# Groundwater Application Review Summary Form

Application # G- 19433

GW Reviewer Stacey Garrison Date Review Completed: 5/13/2025

TO: Water Rights Section Date May 13, 2025  
 FROM: Groundwater Section Stacey Garrison  
 Reviewer's Name  
 SUBJECT: Application G- 19433 Supersedes review of \_\_\_\_\_  
 Date of Review(s) \_\_\_\_\_

Well Statistics

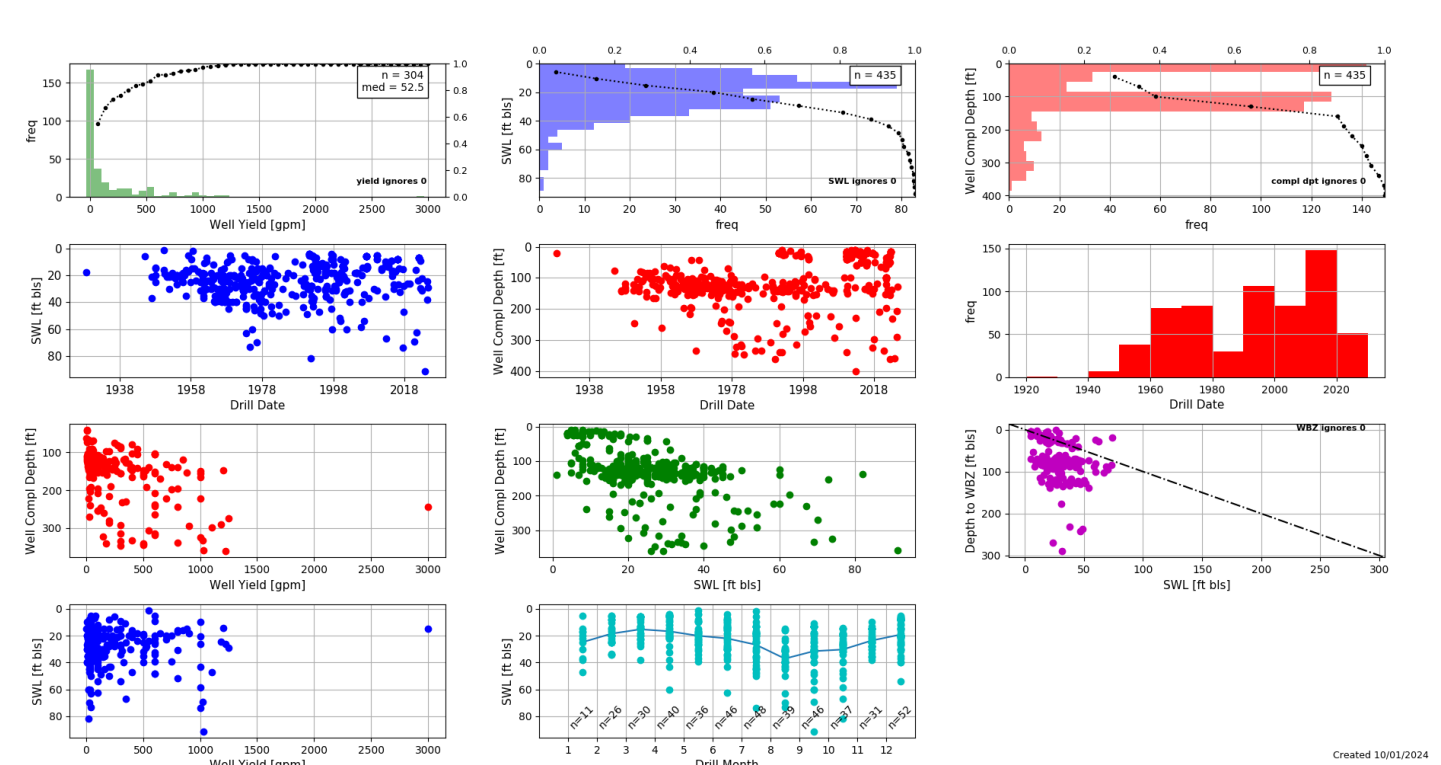
- A review of statistics for nearby well records was completed and compared with the proposed maximum rate of 0.1 cfs (44.9 gpm) for this application (see **Well Statistics**). The median reported well yield is 52.5 gpm, and the maximum reported yield is 3,000 gpm. The proposed rate for this application is 44.9% of the median and 1% of the maximum reported yield. Within a

mile of the proposed POA, well yields range from 18 to 1,250 gpm with a median of 100 gpm. The proposed maximum rate of 0.1 cfs (44.9 gpm) is likely within the capacity of the groundwater resource.

### Water-Level Measurements in Nearby Wells

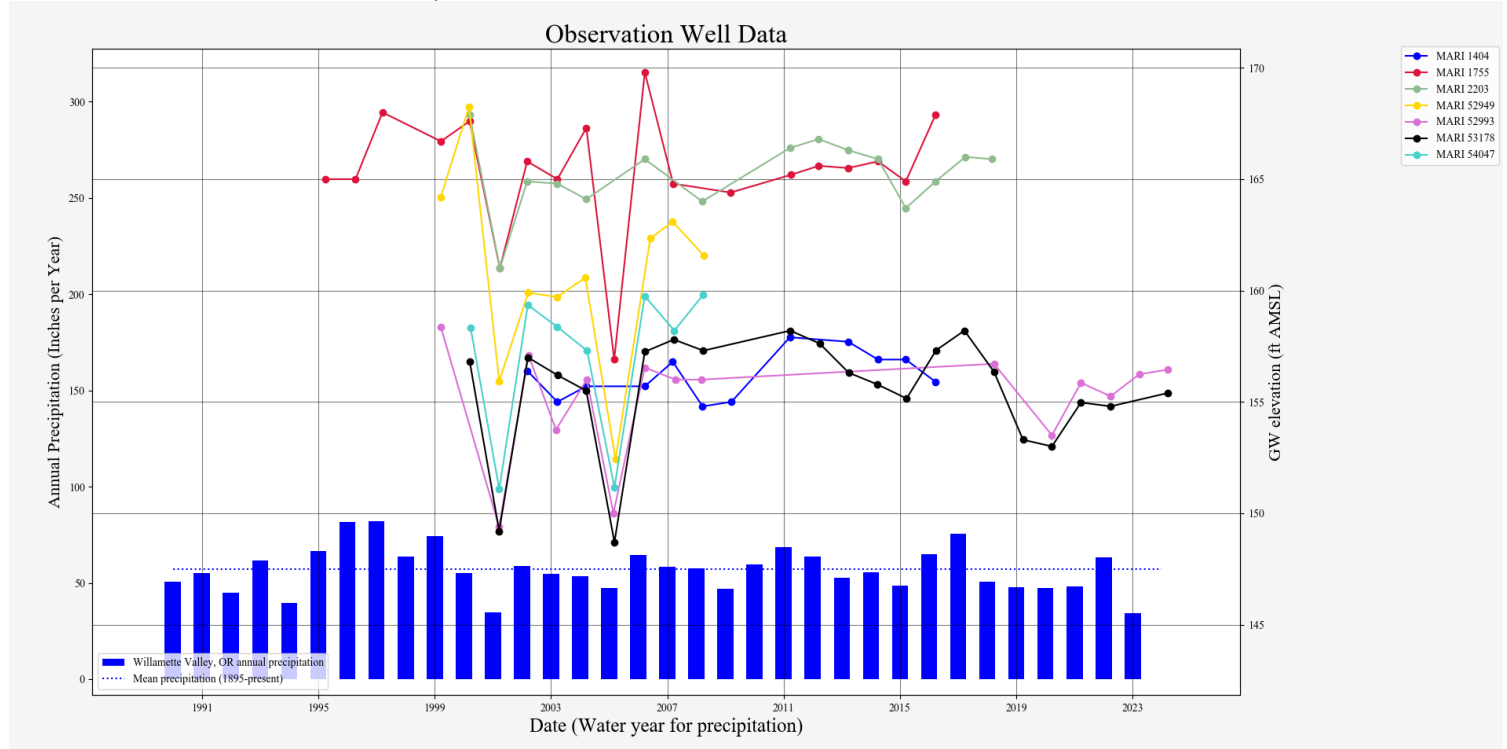
Water level trends for wells that utilize alluvial aquifers within a mile of the POA appear to be stable (see [Water Levels Measurements in Nearby Wells](#)). Although notable declines occurred in multiple wells in 2001 and again in 2005, water levels have since recovered and remain stable. There are 42 groundwater POAs on 42 water rights within 1 mile of the subject POAs. However, the steady trends in water levels indicate that the groundwater resource is not likely over appropriated and the proposed use is within the capacity of the resource.

### Theis Interference Analysis

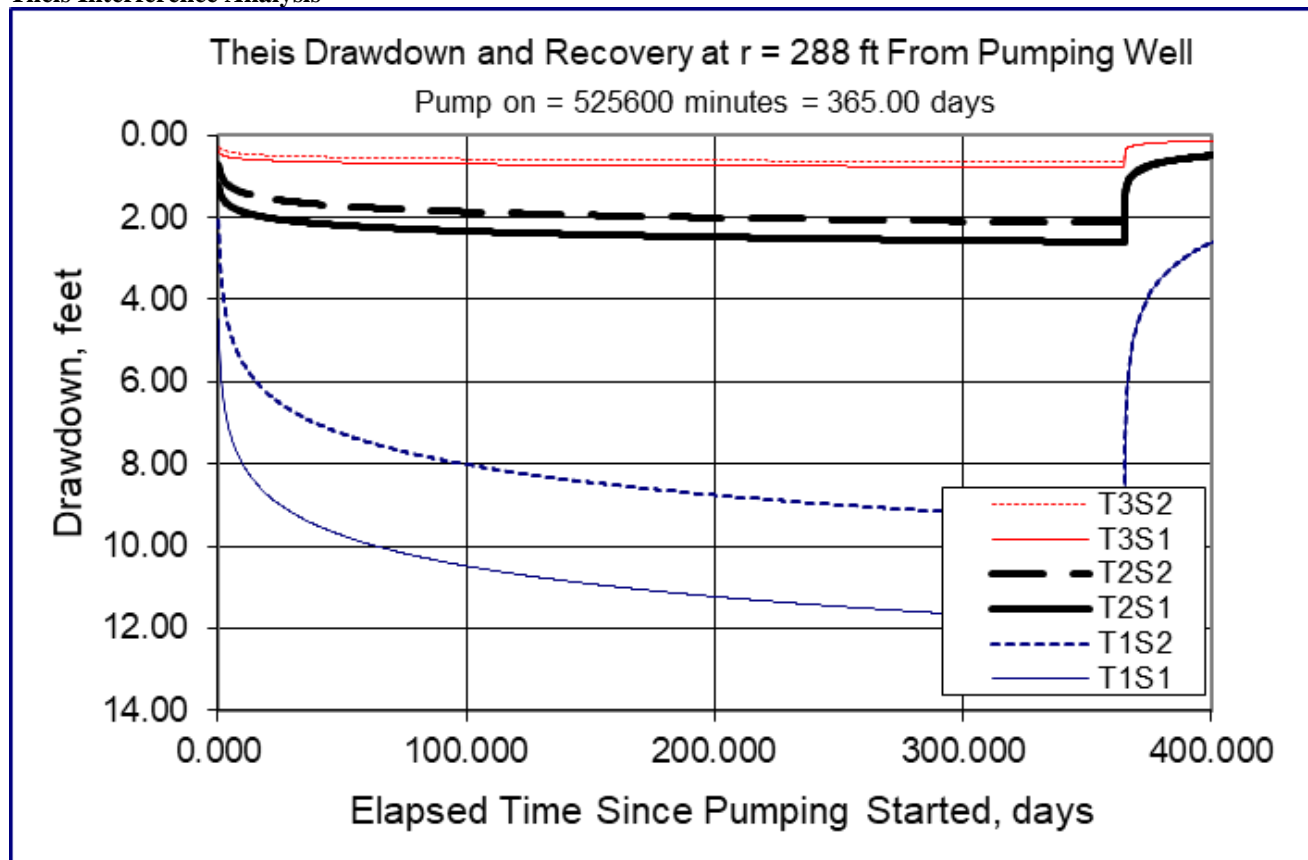
The nearest groundwater user to one of the POAs is MARI 18407, located 288 ft northeast of POA 1 (MARI 2242), at an elevation of 177 ft amsl. It is likely the proposed use would cause some degree of well-to-well interference with MARI 18407. To assess the degree of drawdown, a Theis drawdown analysis was conducted for the proposed use (see [Theis Drawdown Analysis](#)). Results indicate that the proposed use is not likely to cause well-to-well interference with MARI 18407 that exceeds the threshold under the standard condition for alluvial aquifers in the Willamette Basin.

Radial distance from pumping well ( $r$ )=288 ft [estimated radial distance to nearest user, MARI 18407]

**Pumping Rate ( $Q$ )= 0.1 cfs (~ 44.9gpm)**

Aquifer Transmissivity ( $T_1$ )= 4,787 gpd/ft (640 ft<sup>2</sup>/day), ( $T_2$ )= 25,133 gpd/ft (3,360 ft<sup>2</sup>/day), ( $T_3$ )= 92,752 gpd/ft (12,400 ft<sup>2</sup>/day)

Storativity ( $s_1$ ) = 0.0001, ( $s_2$ ) = 0.001 [Conlon et al 2005, Table 1 and 2 values for MSU]

Total pumping time=365 days [Year-round nursery]

Based on this analysis of the available data and under the assumptions previously identified, groundwater for the proposed use will likely be available in the amounts requested and within capacity of the resource. The conditions specified in B1(d)(i) and B2(c) are recommended to protect senior users and the groundwater resource.
